***RE: Amendment No. 2 to the Jade Bar Parking Analysis dated February 25, 2013
Second Submittal***

The purpose of this letter is to serve as Amendment No. 2 to the *Jade Bar at Sanctuary Camelback Mountain Parking Analysis* prepared by CivTech and dated February 25, 2013. This second amendment to the parking analysis was requested by the Sanctuary for submittal to the Town of Paradise Valley. It has been necessitated by the addition of up to 45 new rental units proposed for The Sanctuary on Camelback Mountain Resort & Spa. This document represents a 2nd Submittal and addresses a comment that "[t]he study should address total approved parking and shared parking." The comment is addressed in a new section before the conclusions.

Sanctuary Interstitial Keys
 The Sanctuary Resort on Camelback Mountain

Project Site Plan

A3
Attachment 1

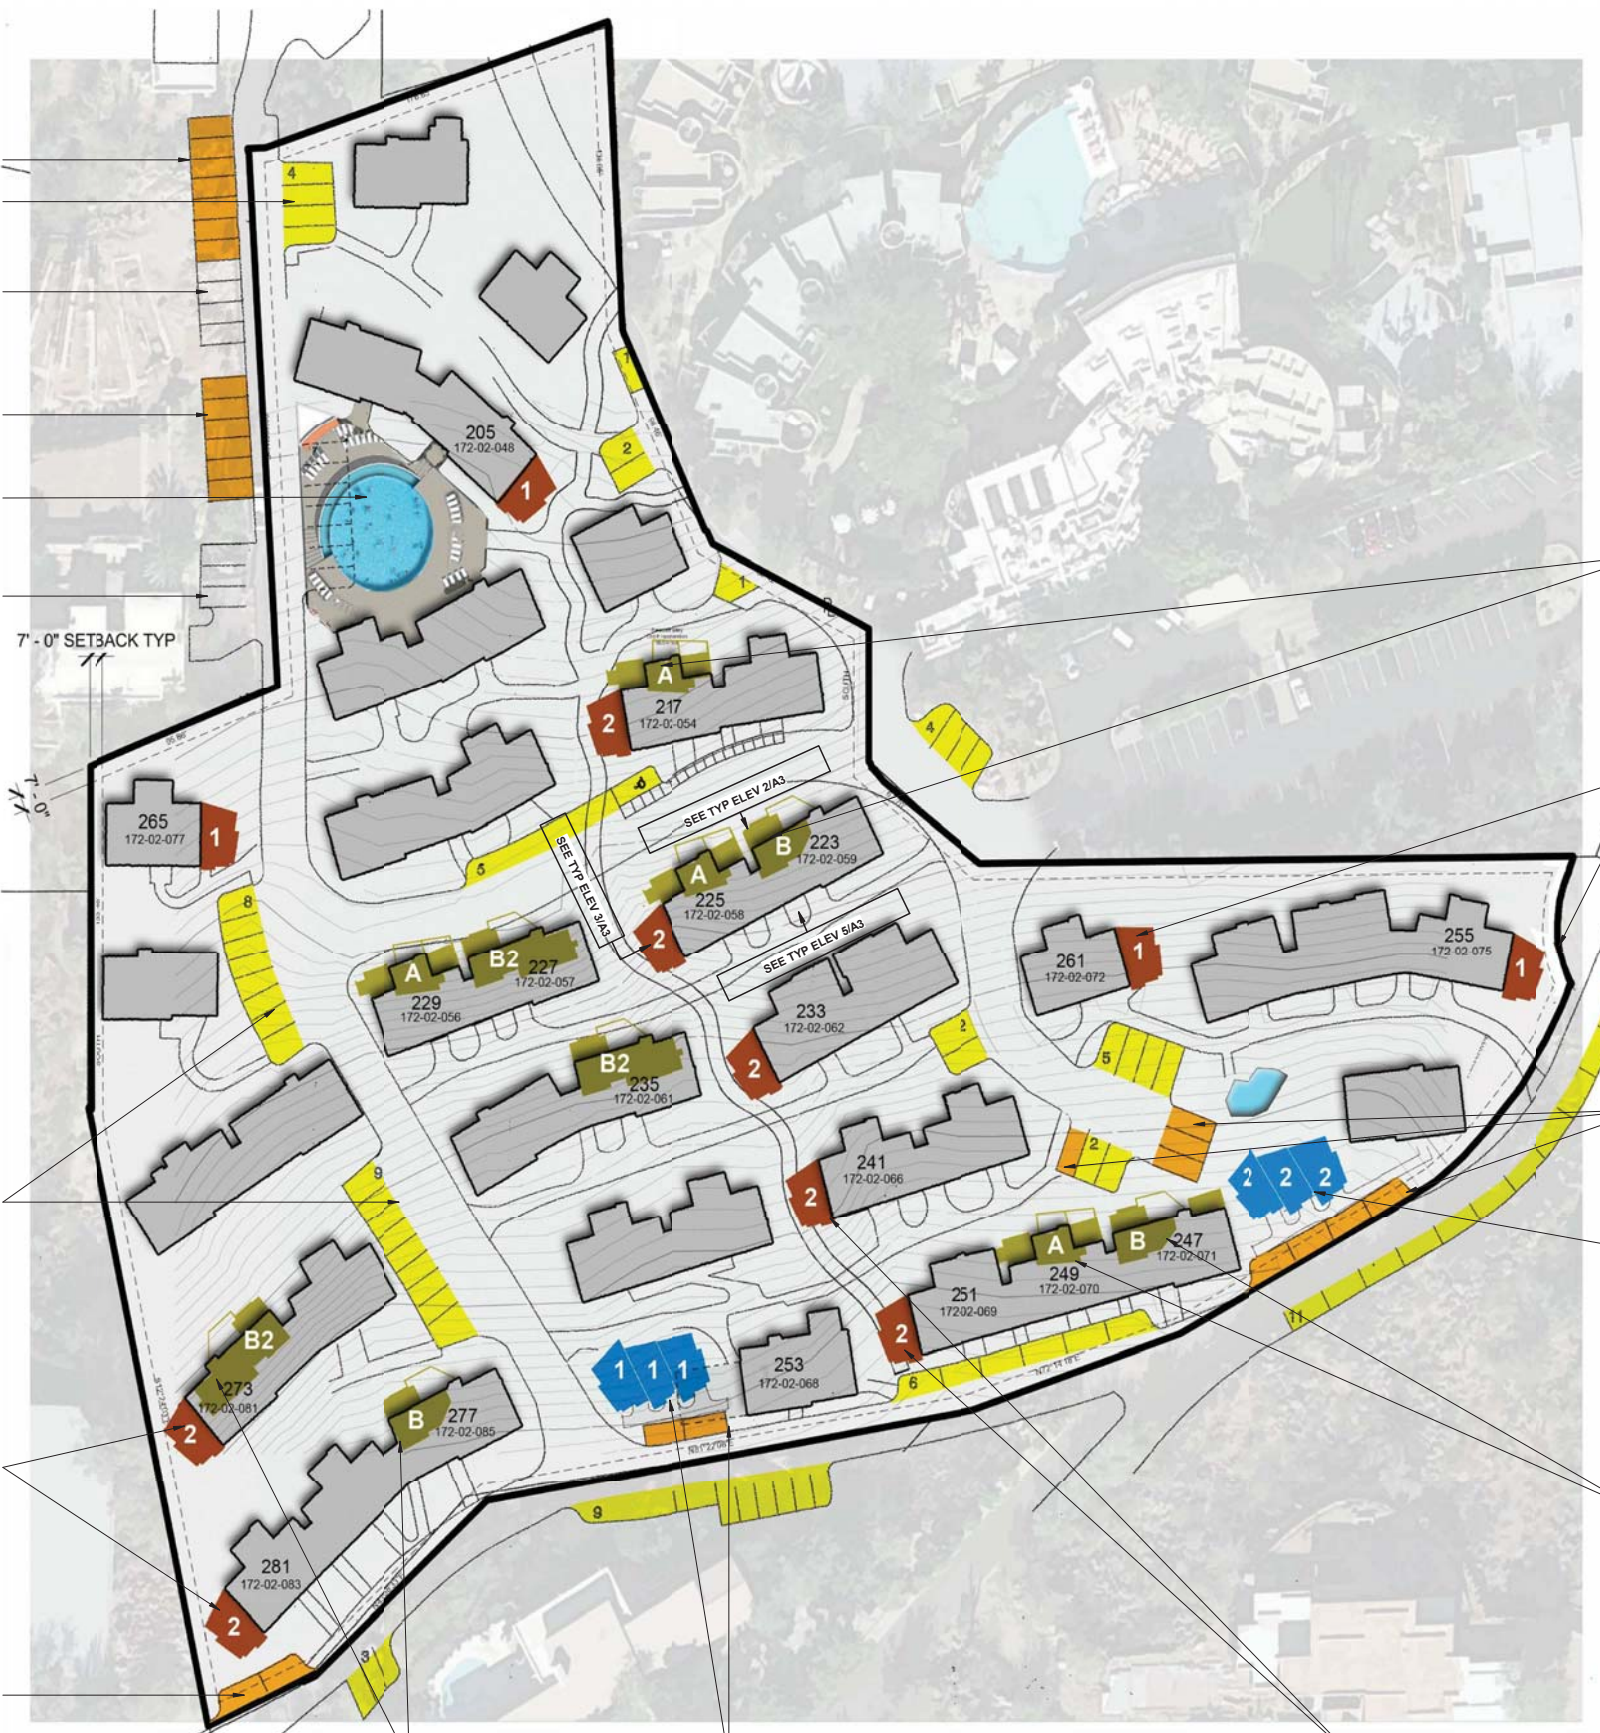
As the reviewer noted, the site plan attached to the first submittal of this Amendment No. 2 clearly showed a net increase of 17 parking spaces, which is corrected herein to 18 new spaces. This fact was noted in the first submittal of the amendment and continues to be noted herein on page 2, in the sentence just before the “ADA Compliance” section.

The site plan provided to CivTech (see **Attachment 1**) shows that 39 1- and 2-floor bungalows will be constructed on the ends of or beneath the existing 41 Casitas. Two clusters of three more bungalows (6 total) will stand free among the Casitas, bringing the total number of new units to 45. Thus, the total number of rental units will be increased from the existing 41 Casitas to a total of 86 Casitas and bungalows. On-site guest units could increase to totals of 155 in the interim condition and 174 in the ultimate condition.

Finally, the number of parking spaces for the Casitas-area rental units will be increased by 18 from the existing 79 spaces (including 1 ADA-compliant space) to 97 spaces. Overall on-site parking will increase to 368 in the interim condition and 391 in the ultimate condition.
